**RE: DENDROBIUM MINE – PLAN FOR THE FUTURE: COAL FOR STEELMAKING (SSD 8194) –  
WOLLONGONG CITY COUNCIL RESPONSES**

ATTACHMENT 1  
RESPONSE TO WOLLONGONG CITY  
COUNCIL COMMENTS

## WOLLONGONG CITY COUNCIL – SUBMISSIONS REPORT RESPONSES

**FIGURE 7**

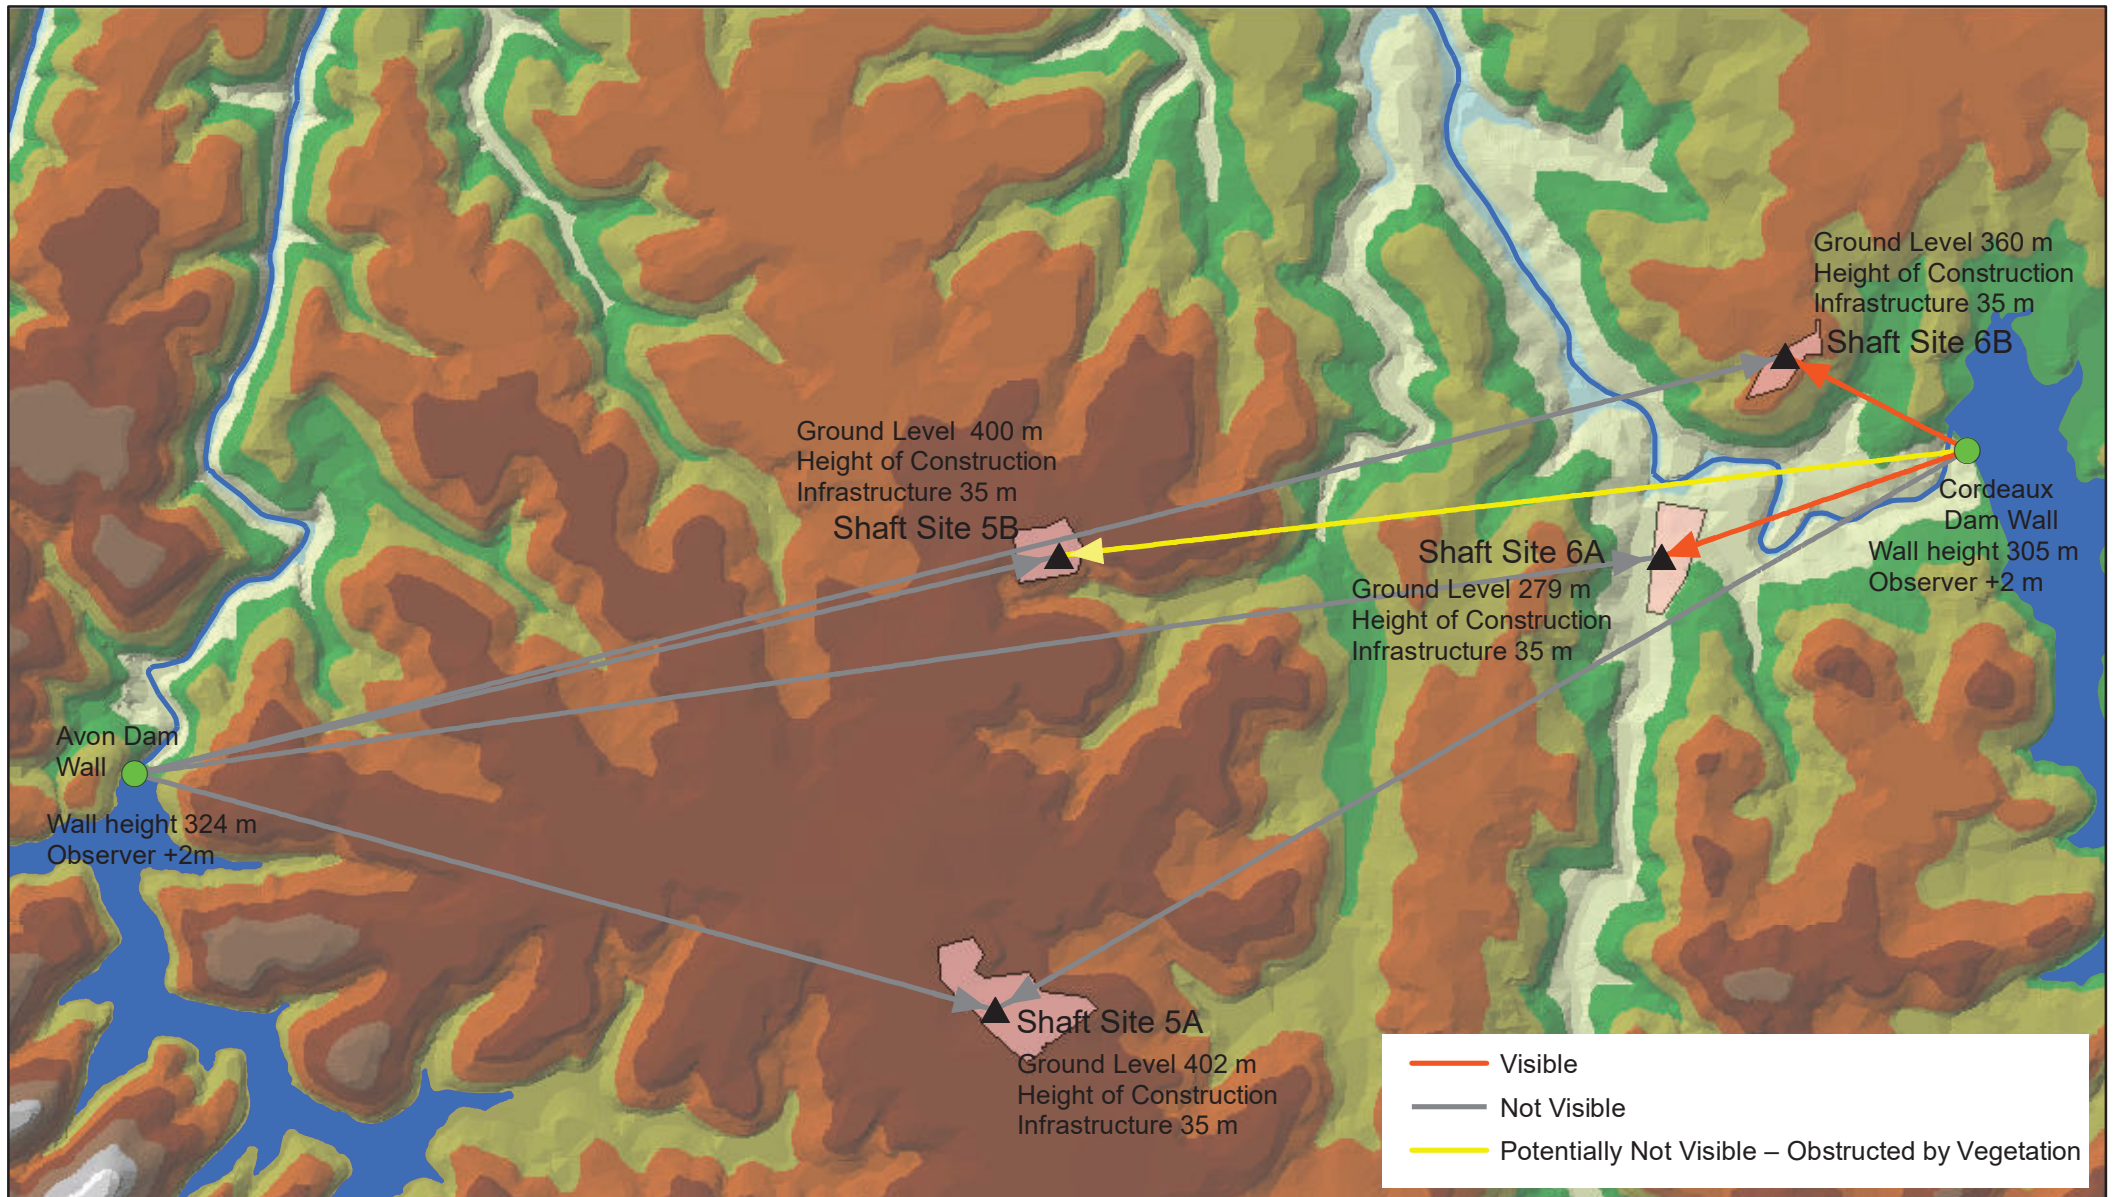
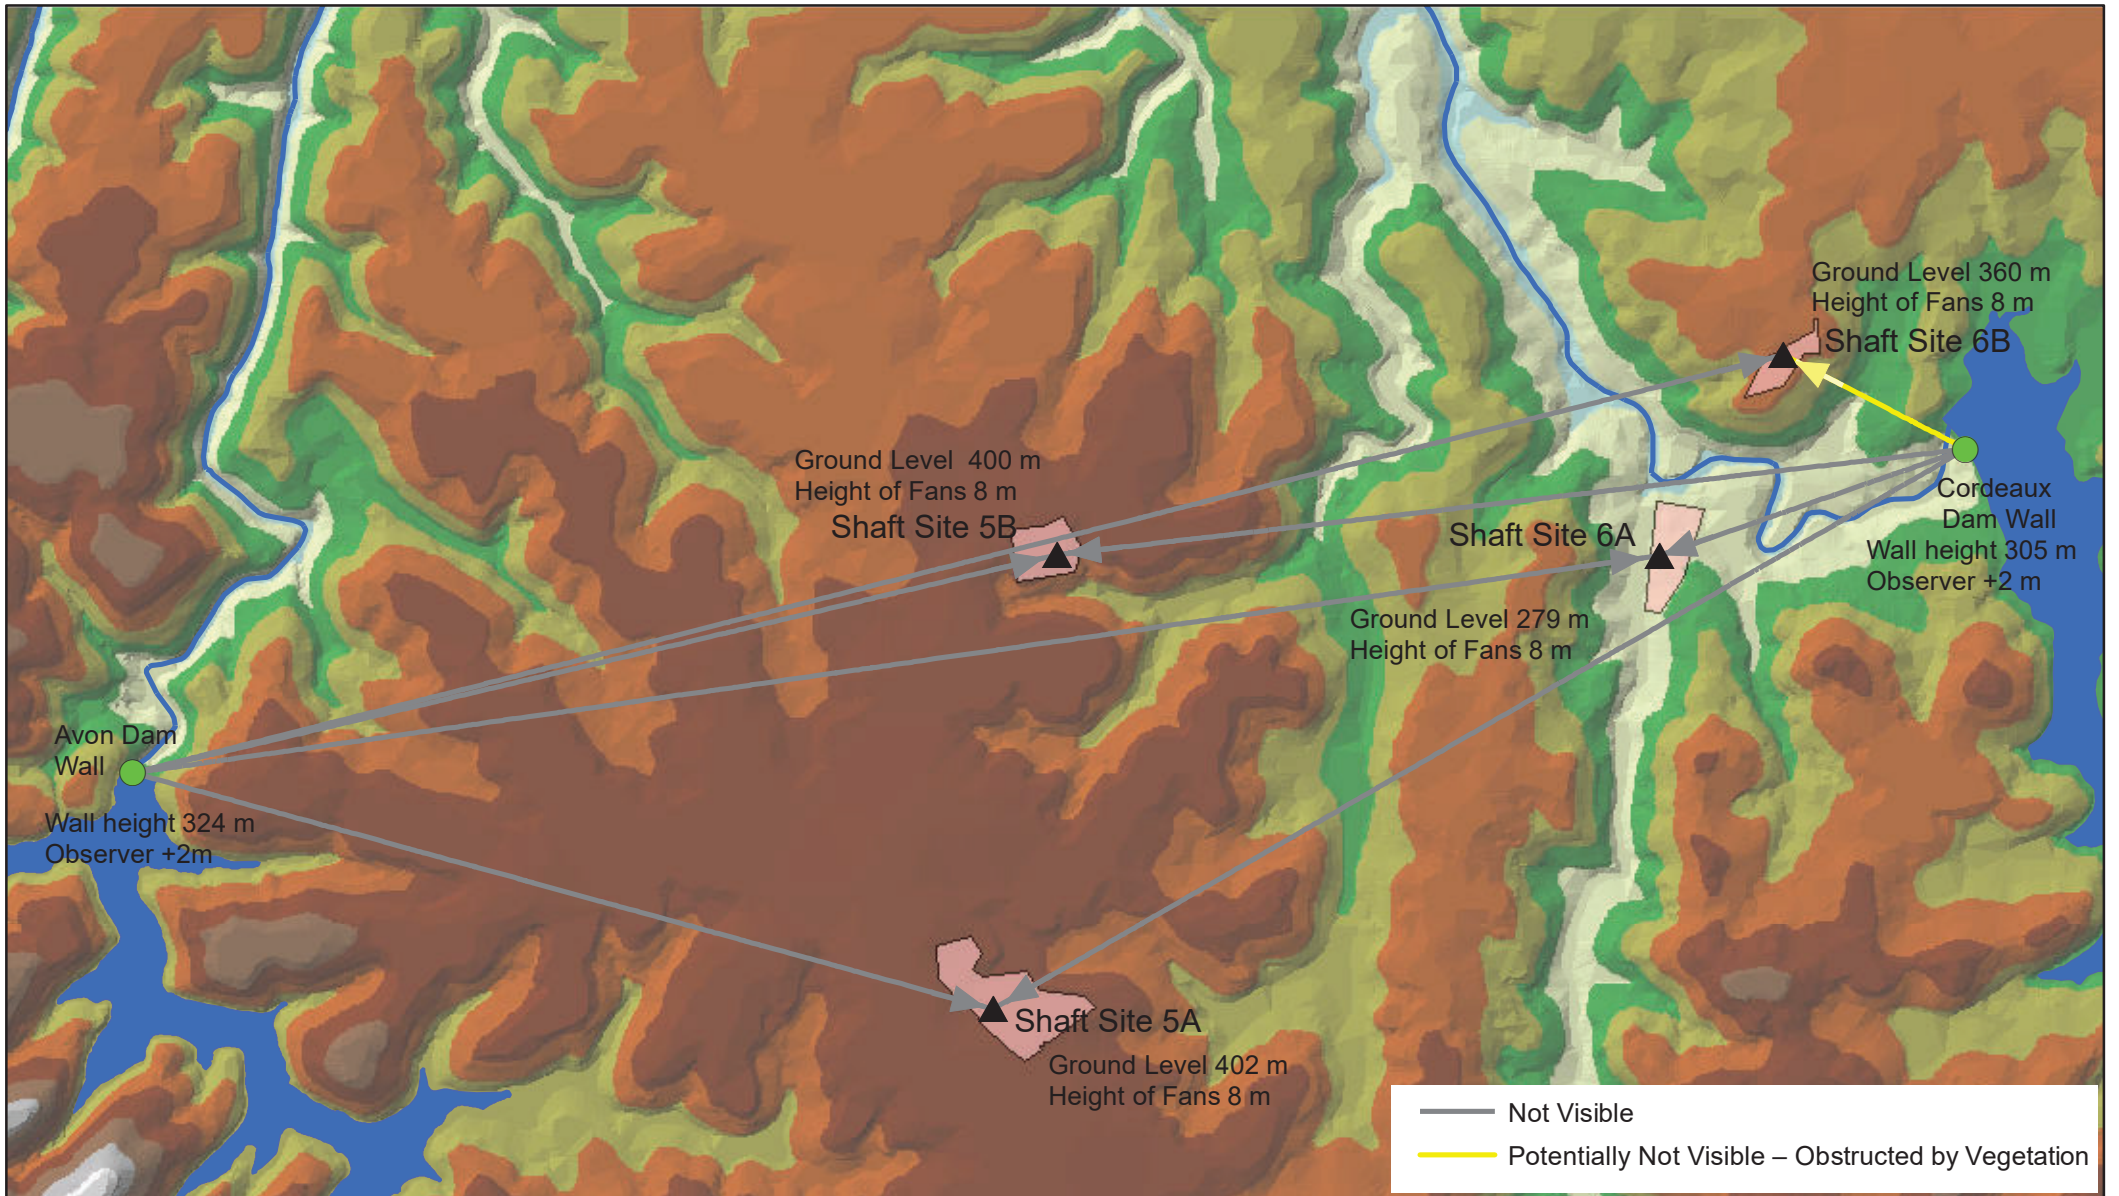
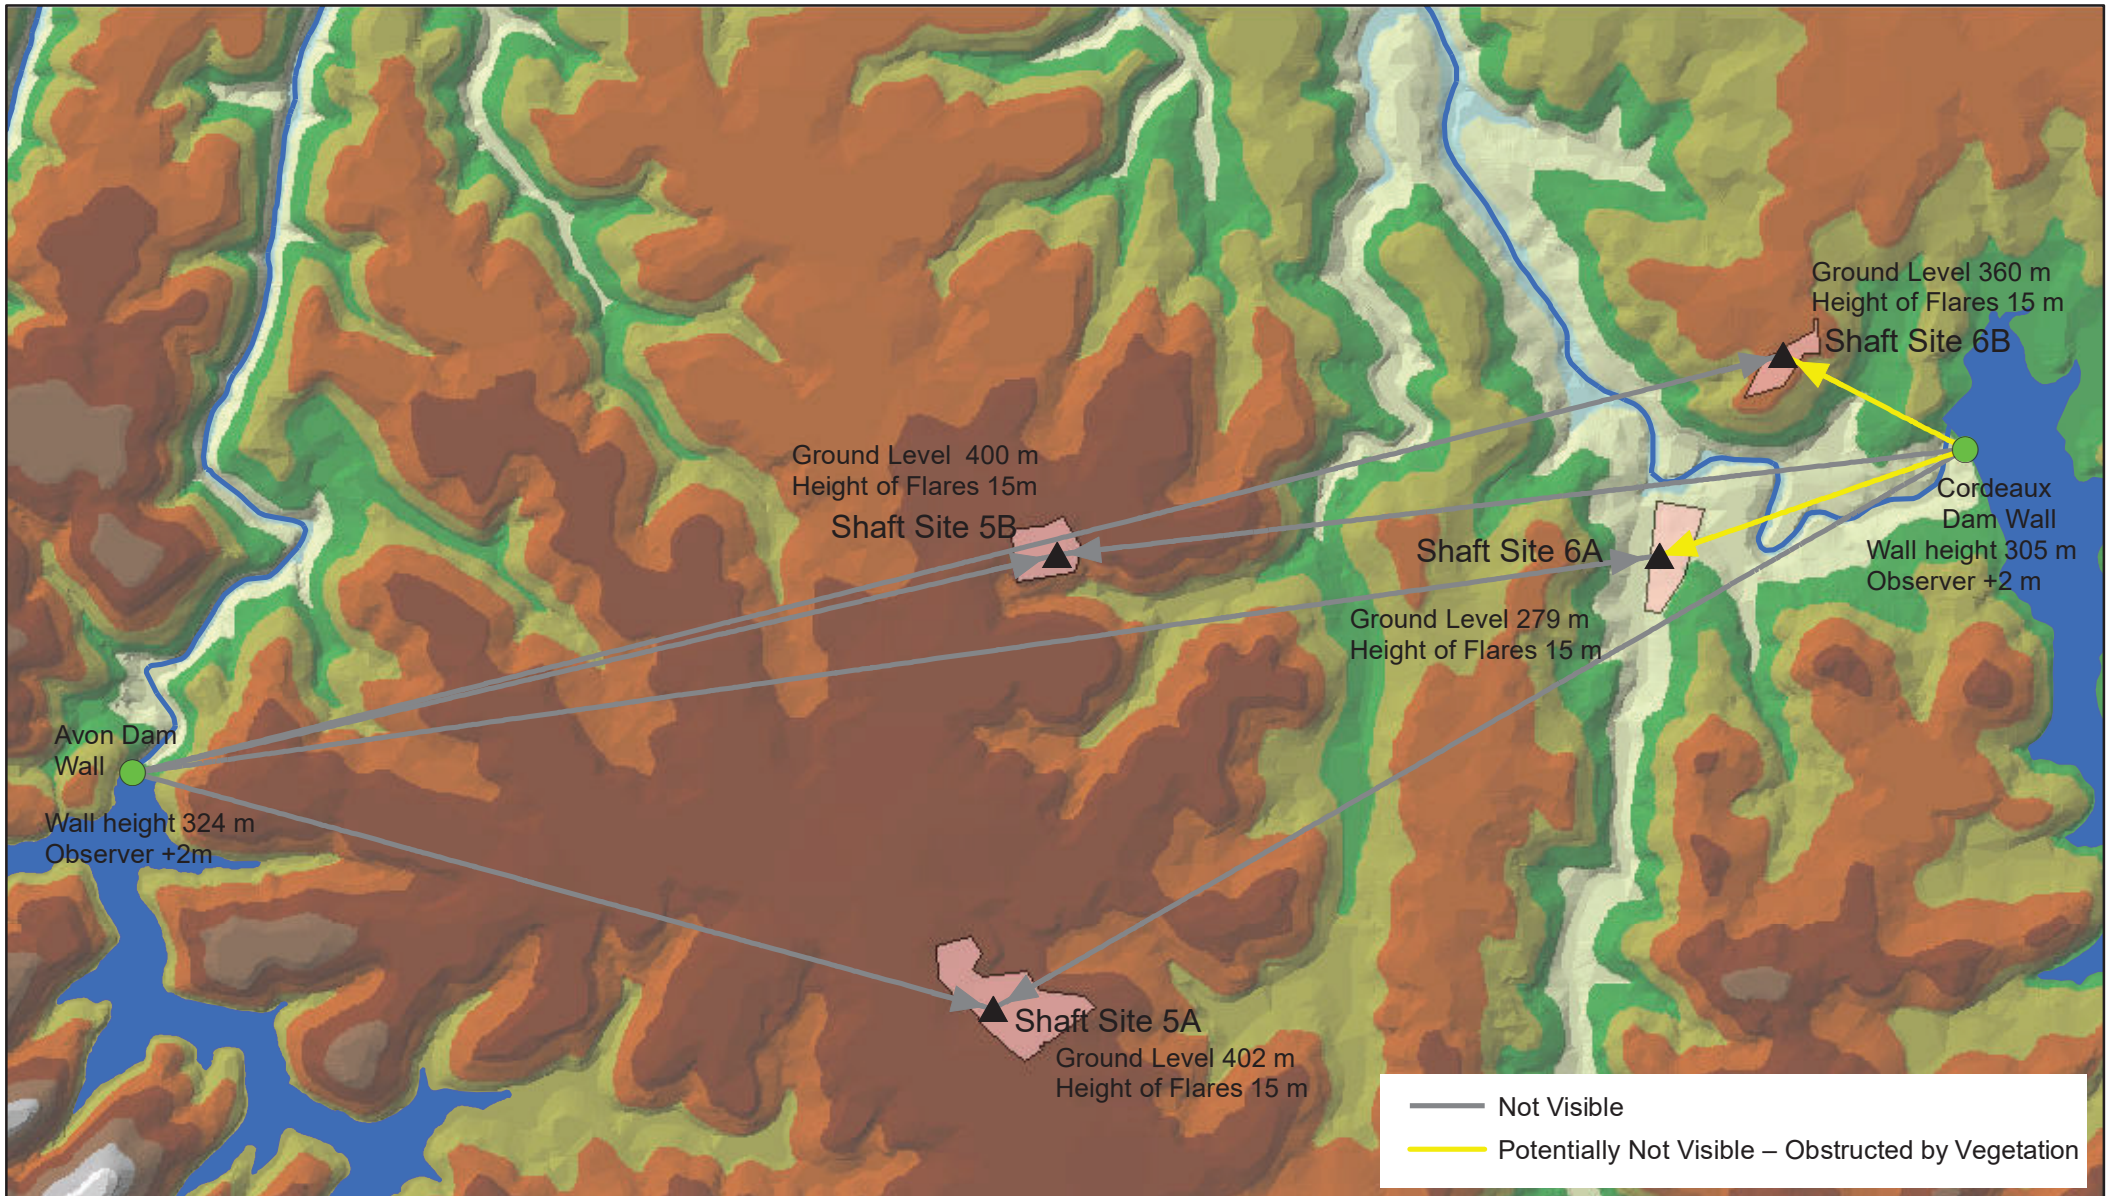
*The impacts of the proposed 15 metre high ventilation shafts on the Illawarra Escarpment Conservation Area are not addressed in the HHA report ... In Council's view, a comprehensive visual impact assessment should be prepared and included as part of the EIS.*

The Illawarra Escarpment Conservation Area is more than 10 km away from the proposed ventilation shaft sites for the Project.

The potential visual impacts of the proposed ventilation shaft infrastructure on identified items of historic heritage are described in the Historic Heritage Assessment (Appendix G of the Project EIS), in particular, from the Avon and Cordeaux dam walls, which are approximately 4.5 km and 1 km away from the closest proposed ventilation shaft sites, respectively.

The basis for the assessment of potential visual impacts by Niche (2019) is illustrated in Figures 7, 8 and 9 of Appendix G of the EIS (reproduced below), and shows that the dam walls were selected as the viewpoints for the assessment as they are the publicly accessible recreational areas with potential views of the infrastructure.

Other viewpoints have not been considered on the basis that, with the exception of access tracks surrounded by dense vegetation, there are no other publicly accessible viewpoints of the proposed ventilation shafts, including from locations within the Illawarra Escarpment Conservation Area.

As such, it is anticipated that the Project ventilation shaft sites would have negligible visual impact on the Illawarra Escarpment Conservation Area.
